Certificate of Appropriateness Decision	CITY USE ONLY
	Case Number: PLCOA20220168 DRHPB Meeting Date: May 04, 2023
NAME OF PROJECT: Harris Building Revision	
PROJECT DESCRIPTION: Proposed change to one new exterior door of the "Harris Building," a property listed on the local historic register, which received COA approval January 19, 2023.

WEST ELEVATION
SCALE: 1/4" = 1'-0"

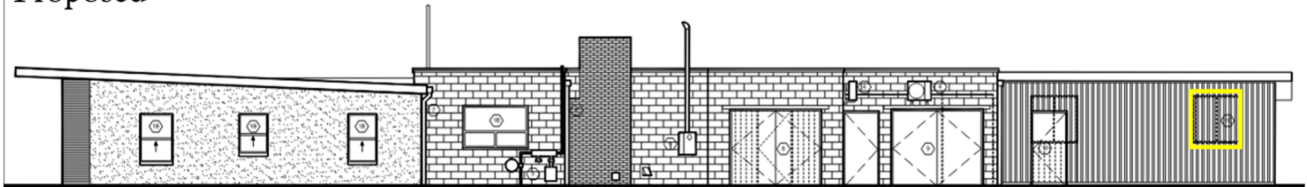
- b. **West Elevation:** the existing south window on the old horse stall (highlighted in yellow) on the elevation drawing below was shown on the elevation drawings to be eliminated; however, the applicant clarified at the meeting that it was not intended to be eliminated but replaced with a single-hung window, which was approved by the Board.
